1131A-01B

S E R V I C E N O T E

1131A Infiniimax Probe Amplifier 3.5GHz

Possible fractured solder joint on input pin

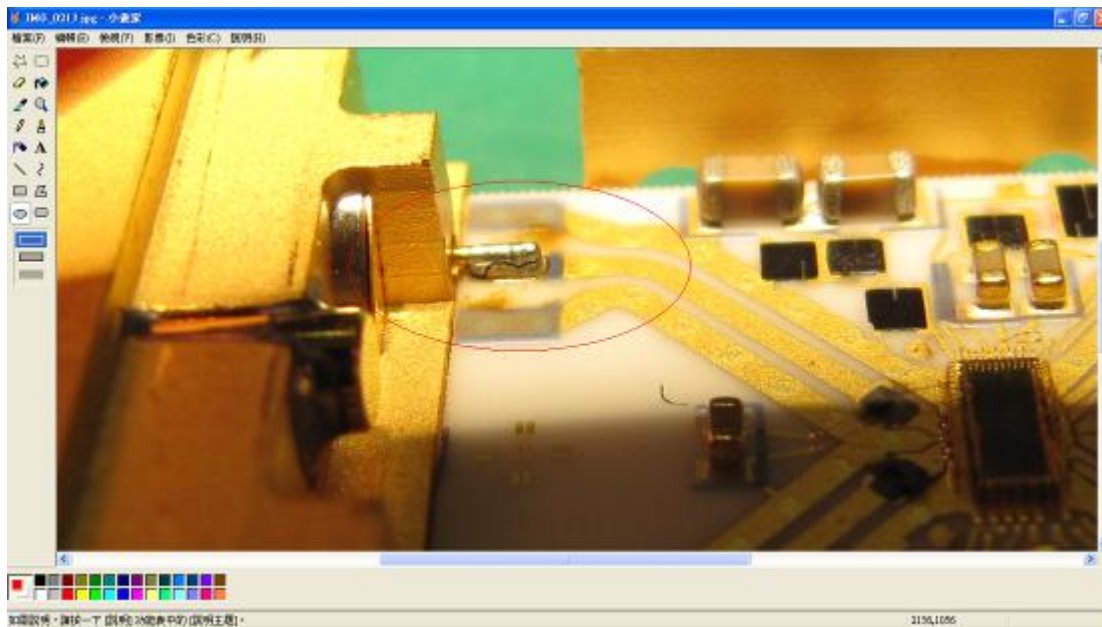
There is a possibility that the input pin solder joint may be fractured. You may also find the input pin bent, broken off, or stuck into the female connector of a probe head.

The above picture shows a fractured solder joint.

The above picture shows where the long pin of the probe amplifier actually got stuck in the female connector of the probe head. When the probe head was removed from the probe amp, part of the probe head female connector stuck to the probe amplifier pin and was pulled out.

5. If you determine that the solder joint is fractured, bent, broken, or probe head parts stuck to a probe pin, replace with a new 01131-68701 probe amplifier. Charge the replacement cost to factory warranty.

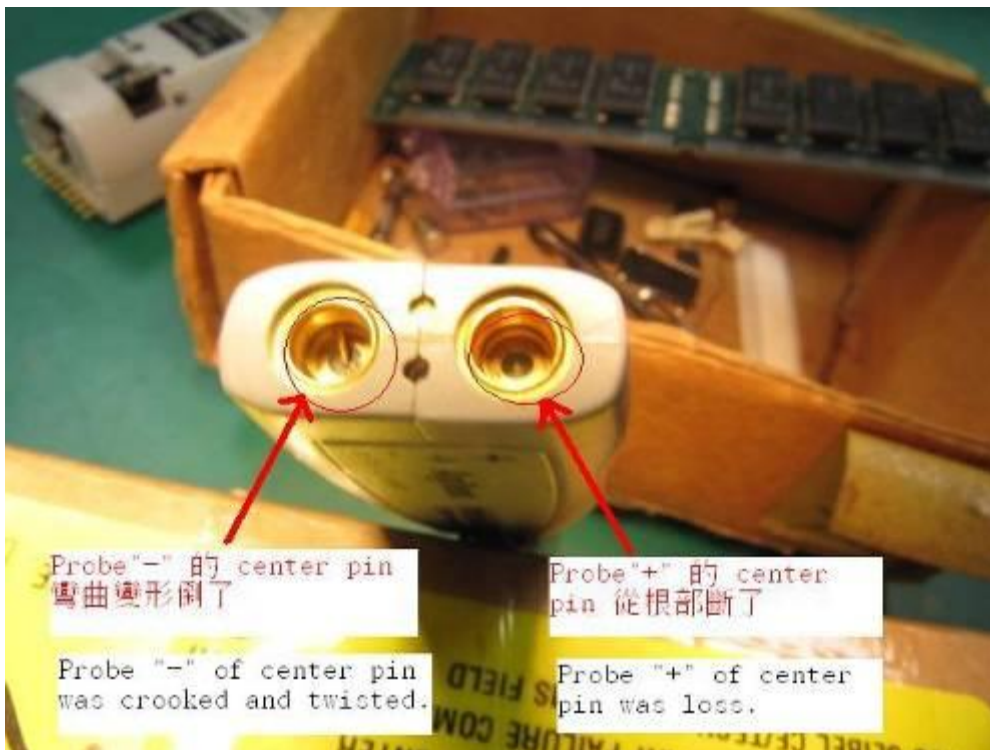
The above picture shows a bent male pin and a broken male pin. The longer male pin could cause the pin to bend or eventually break when connected to a probe head.

If you find the above mechanical defects, replace with a new 01131-68701 probe amplifier.
